PLANNING STATEMENT

Maxika Homes

For the residential redevelopment comprising demolition of existing single storey building and erection of 16 dwellings together with associated works at 220 Elgar Road South.

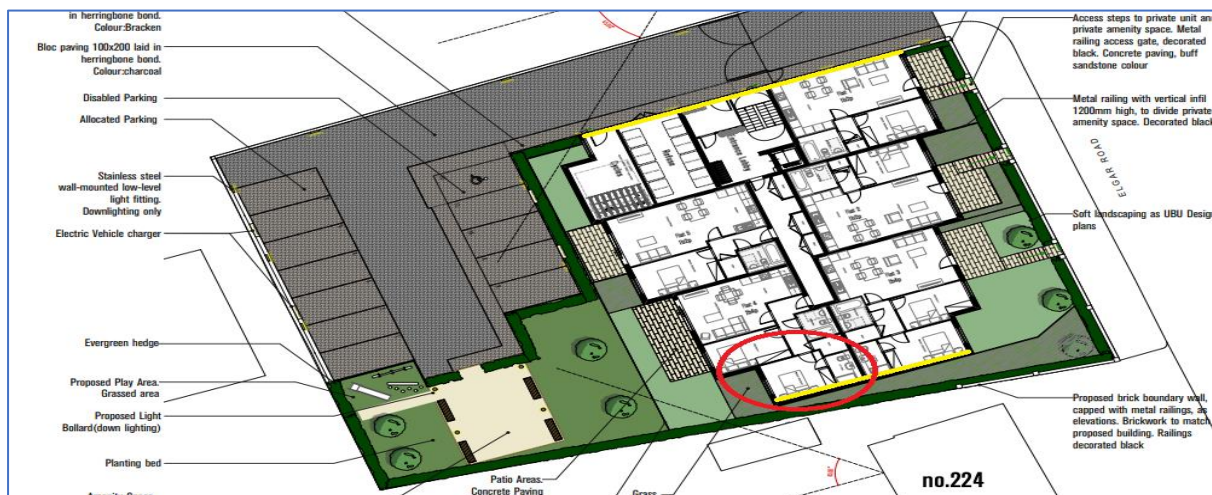
The garden of No.224 is set back of the main two storey element by a conservatory and it is enclosed on the northern boundary by an existing outbuilding. Looking at the siting/scale of the proposed building in relation to this context, the rear building line of the proposed two storey element (already stepped down at this point) is broadly aligned with the conservatory. Notwithstanding compliance with the 45 degree angle, the massing of the proposed building does not feature in more obscure views from the primary amenity space immediately to the rear of No. 224. The remainder of the garden for No. 224, which is substantial, is completely unaffected proposal given this relationship.

The other fundamental point here is that the outlook for No.224 is clearly west towards Waterloo Meadows for two reasons – firstly, that is the orientation of the garden, and secondly occupiers will naturally manage the layout and use of the external amenity area to create views/outlook to the area given that it forms an attractive landscaped backdrop.

Nevertheless, the southern section of the scheme has been reduced to part single storey where the development gets closer to the neighbouring boundary. This change will ensure that the proposal will not be overly dominant when viewed from the neighbouring properties.

Access points to the front of the ground floor units

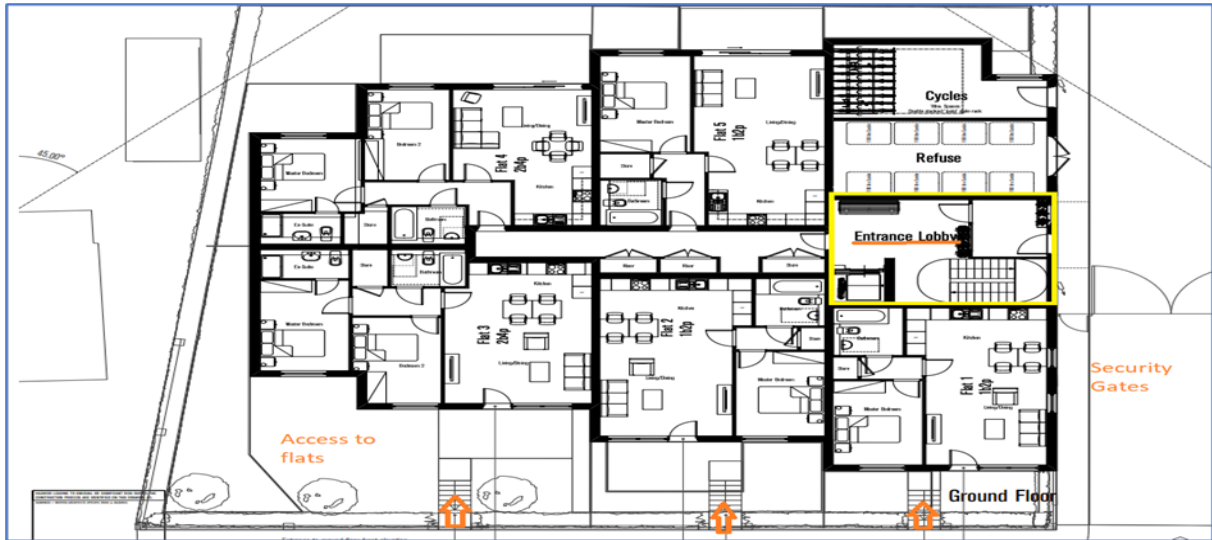
'The development proposes a layout with flats to the front and rear of the site accessed by a side entrance door leading to a long corridor and stairwell. This is a poor and insecure choice of layout with no legible front door/entrance feature and instead the communal door is approached along a secluded side vehicle access. The entrance door would be a narrow and unwelcoming entrance with no overlooking from habitable windows in the development and dwarfed in scale and importance by the adjacent bin store doors. The above design flaws would fail to create a safe and accessible environment, where crime and disorder or fear of crime can undermine quality of life or community cohesion for future residents, contrary to Policy CS7 (Design and the Public Realm) of the Reading Borough Local Plan (2019)'.

The ground floor flats to the front of the property will now have individual accesses which improves the security to the front of the property and provides an improved landscape to the front of the building – please see below:

The side access has been amended such that security gates have been added and an entrance lobby created to improve this entrance – Please see images above and below.

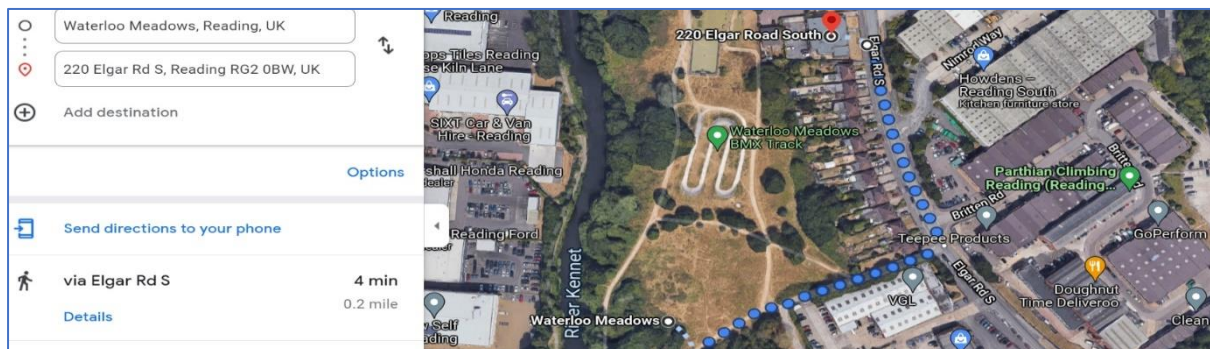
'The proposal would be substandard in terms of amenity space for the number of flats, which is not reflective of the context of development in the vicinity. Due to the amount of site coverage by the proposed flats and the amount of parking proposed there is limited opportunity for secluded landscaped amenity space to be provided to serve the future residents. For these reasons, the proposal would fail to provide a suitable level of landscaping or amenity space for the development, contrary to policies CC7 (Design and the Public Realm), CC8 (Safeguarding Amenity) of the Reading Borough Local Plan (2019) and EN14 (Trees, Hedges and Woodland) of the Reading Borough Local Plan (2019)'.

The target is 340sqm against provision of 425sqm on a site adjacent to existing POS. What is being sought through Policy H10 is a general requirement across the plan area not taking into consideration the context of each site. This is acknowledged at paragraph 4.2.40 of the Local Plan, which states (my underlining for emphasis) "Policy H10 seeks to secure private and communal outdoor amenity areas on all residential developments, the extent of which will be guided by the site's proximity to quality public open space.

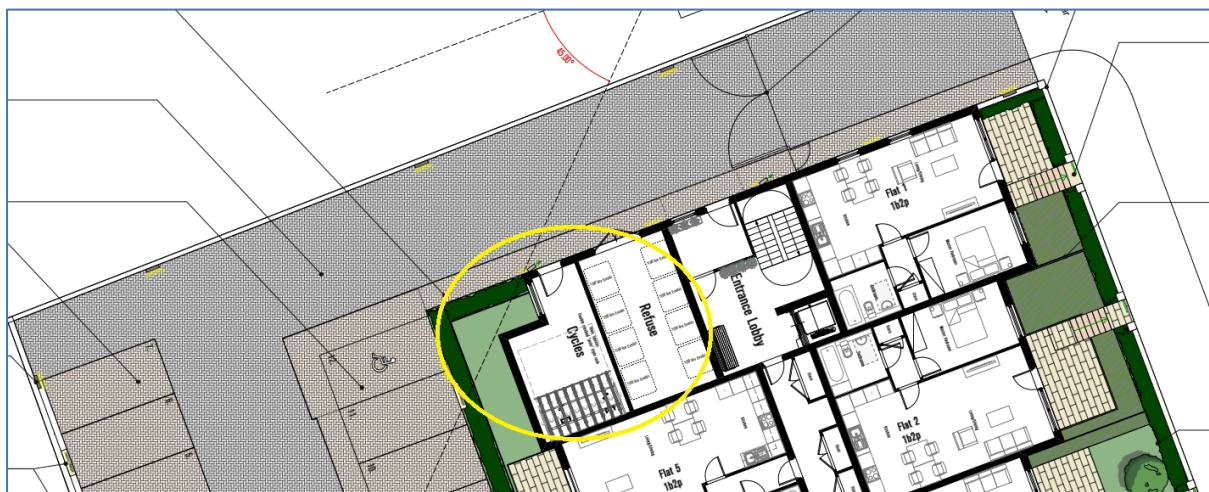
'The cycle store shown is substandard in terms of dimensions and capacity and is in a secluded location, at risk of break-ins. The location and design of the cycle store is therefore unacceptable as it would not provide sufficient, useable cycle parking and it would fail to create a safe and accessible facility, contrary to policies TR5 (Car and Cycle Parking and Electric Vehicle Charging), CC7 (Design and the Public Realm of the Reading Borough Local Plan (2019) and the Council's adopted SPD, 'Revised Parking Standards and Design' (2011)'.

The cycle store has been amended and it is now internal to address this issue. Please see image below.
